Kent Road, Pascoe Vale

Road Safety Audit

Audit Stage: Post-completion

DOCUMENT NUMBER: S20220433-REP-001-Av01-RSA Kent Rd Pascoe Vale

Photo 9: Retro Reflective markers help define the speed hump

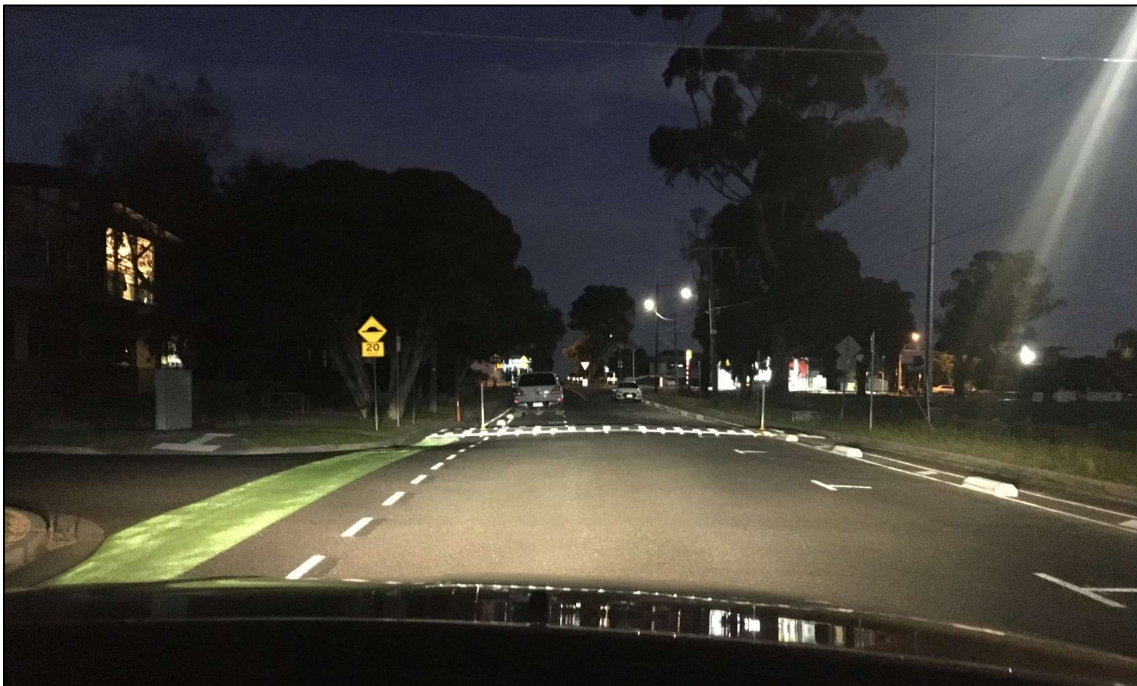
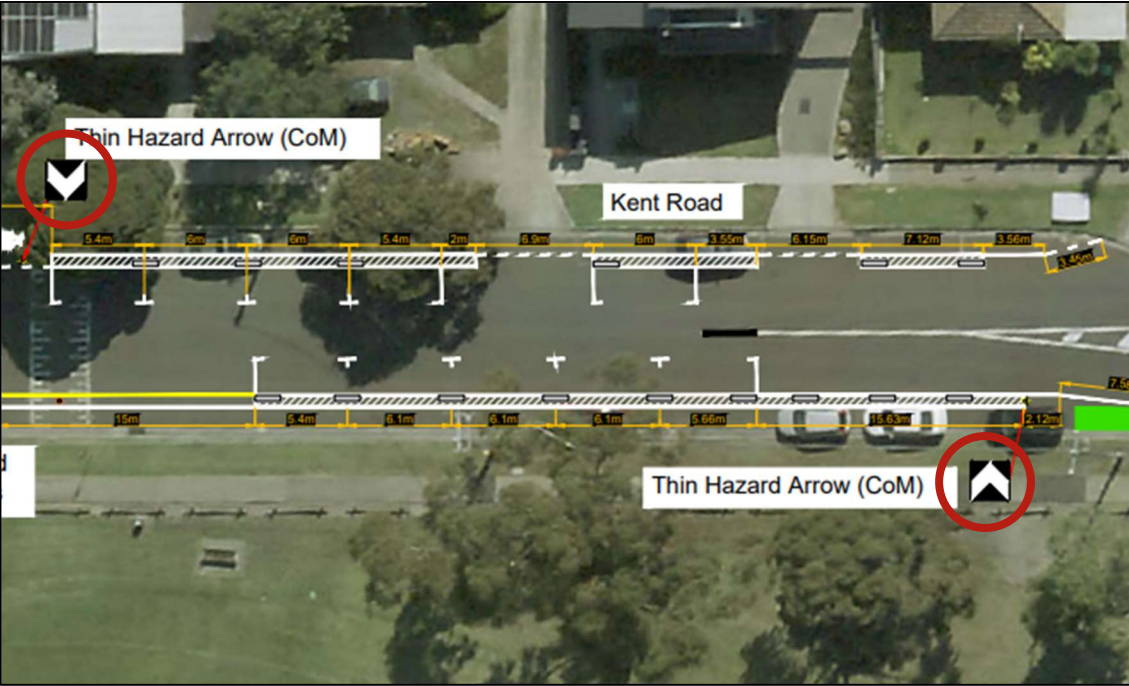
Audit Findings	Risk Assessment			Recommendations	Responsible Officer	
	Likelihood	Severity	Level of Risk	P – Primary S – Supporting	ST – Step Towards N – Non-Safe System	Accept Yes/No Comments
4. Reflective markers dislodging easily from pavement. The lack of reflective markers decreases the visibility of the speed hump at night.  	Rare	Moderate	Low Safe System energy within tolerable levels	Rectify and reinstate reflective markers (S)	Y	Have raised a works order as part of regular maintenance, and will continue to monitor during the trial.
